**RE: STAGE 3 (DFO) EASTERN CREEK QUARTER
PROPOSED CHURCH STREET TRAFFIC SIGNALS**

**RE: STAGE 3 (DFO) EASTERN CREEK QUARTER
RESPONSE TO MATTERS RAISED BY TFNSW**

1. As requested we have reviewed the matters raised by TFNSW in its letter dated 30 March 2021. The matters raised and our response is set out below.

Revised Access Arrangements

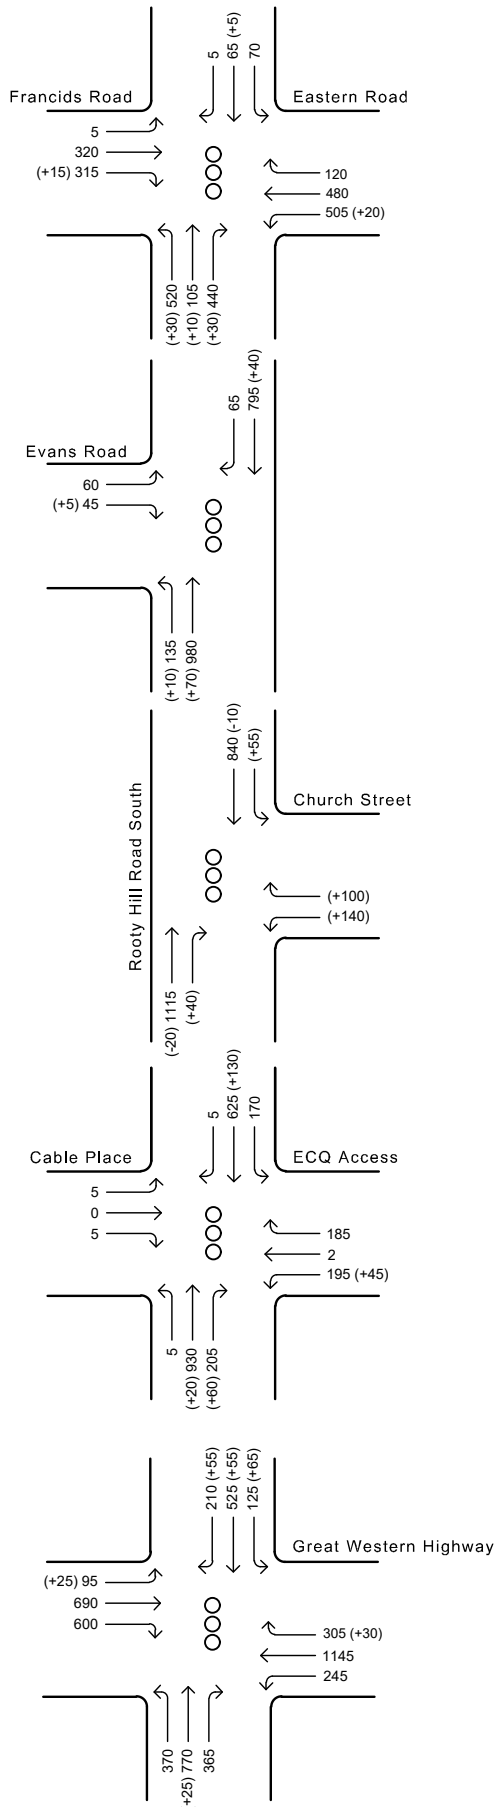
The first vehicular access on Church Street closest to the intersection with Rooty Hill Road South is not supported due to potential queuing impacts on Rooty Hill Road South. All vehicular access should be provided at the northern boundary of the site.

15. We understand that the reason for TfNSW not supporting the current location for access to the at-grade car park is a concern that queuing may extend back from the intersection with Church Street and block access to the site. To address this concern the at-grade car park access has been relocated further to the east some 170 metres from Church Street. This is well clear of the

potential queuing from Church Street, The updated SIDRA analysis found a 95% back of queue on Church Street of 50 metres and 65 metres in the weekday afternoon and Saturday midday peak hours respectively.

**Base case weekday afternoon
peak hour traffic flows plus
development traffic
Figure 2**

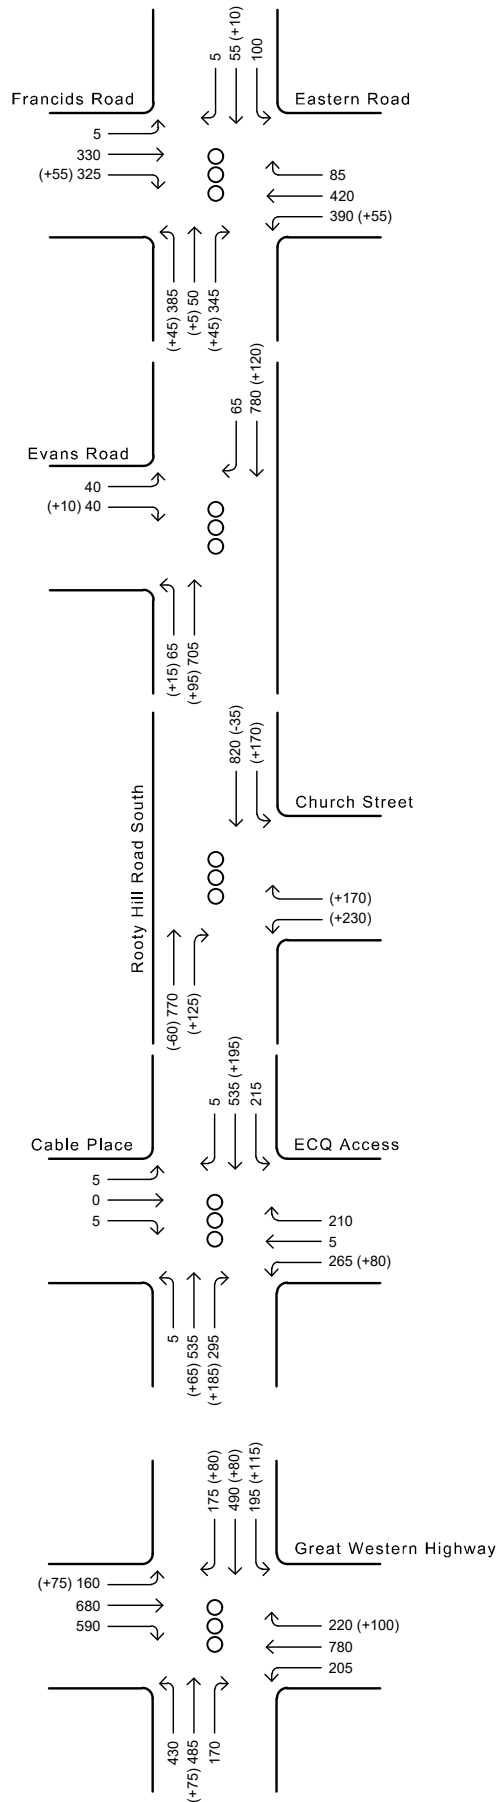
6. Our traffic report that accompanied the SSD assumed that:
 - the split of traffic departing Stage 3 to the south was split 50% between the Church Street and the Goldsbro Glade connections to RHRS; and

- that the split of traffic between in and out was 50% in and 50% out,
7. With respect to the first point, further development of the design of the internal connection between Stages 1 and 3 suggests that this split would be 75% via Church Street and 25% via Goldsbro Glade.

8. With respect to the second point, the assumption of 50% in/50% out is appropriate for the midday peak period but not for the afternoon peak period. Further information on the operation of DFO has advised that the split in the afternoon peak period is 35% in/65% out.

9. Figures 2 and 3 show updated distribution of Stage 3 traffic on the site accesses and along RHRS.
10. Based on the above we have estimated traffic flows along Church Street as set out below.

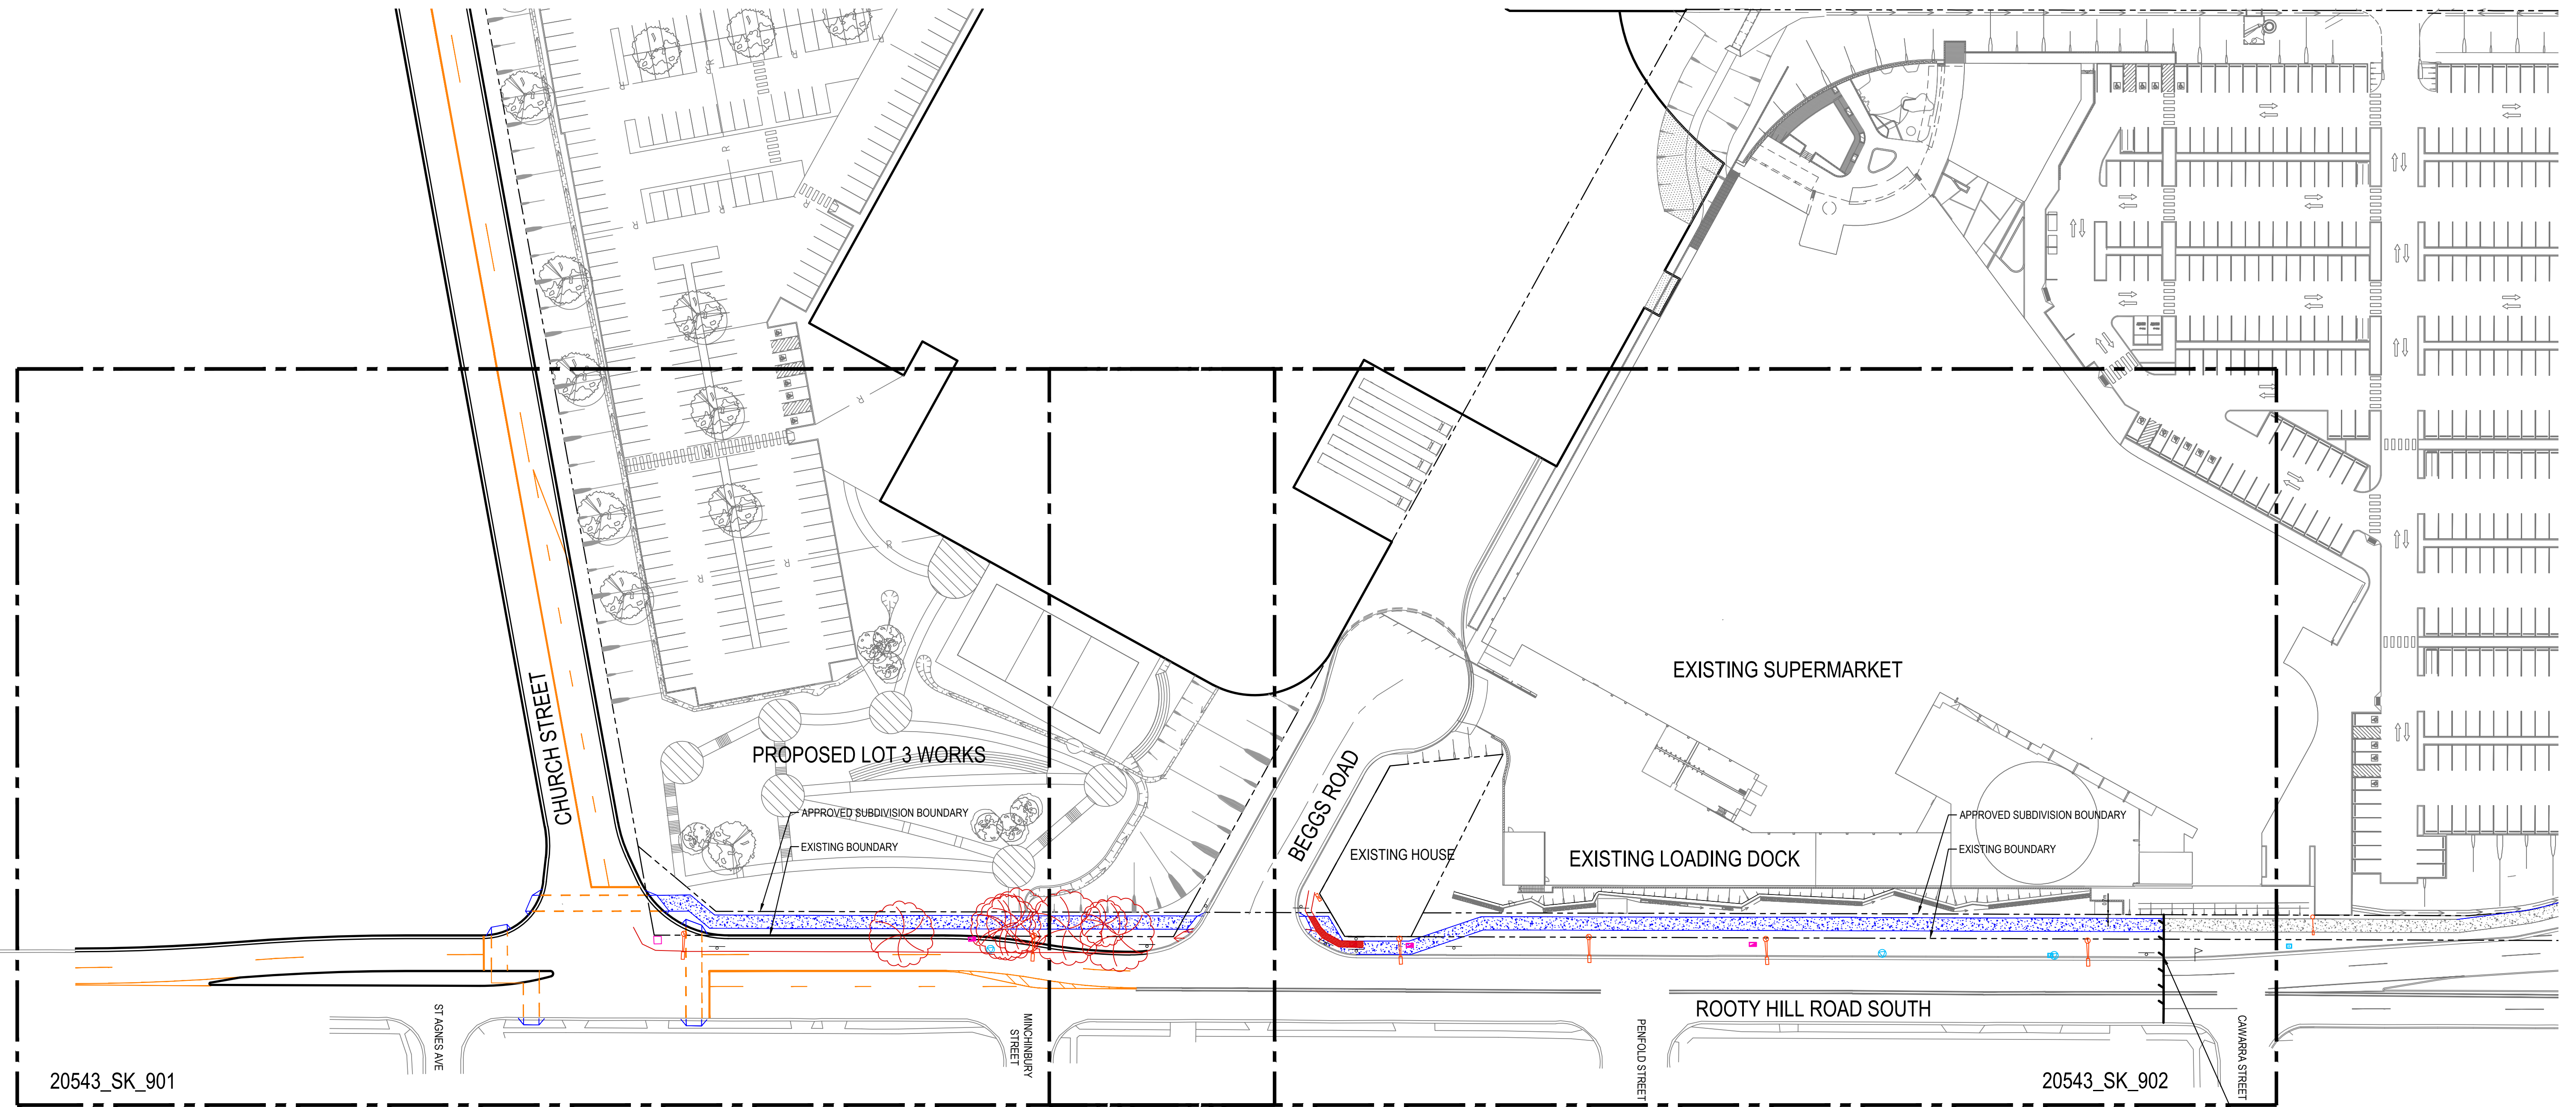
The applicant has not provided a shared pedestrian path along the Lot 1-3 Rooty Hill Road South site frontage to provide pedestrian and cyclist connectivity in the locality to the Eastern Creek Business Hub site. This was discussed with the applicant on 5 August 2020. The existing pedestrian path needs to be upgraded into a shared cycle/pedestrian path

16. An updated plan has been prepared showing a shared pedestrian path along the RHRS frontage of Lots 1 to 3. This is provided in Attachment C.
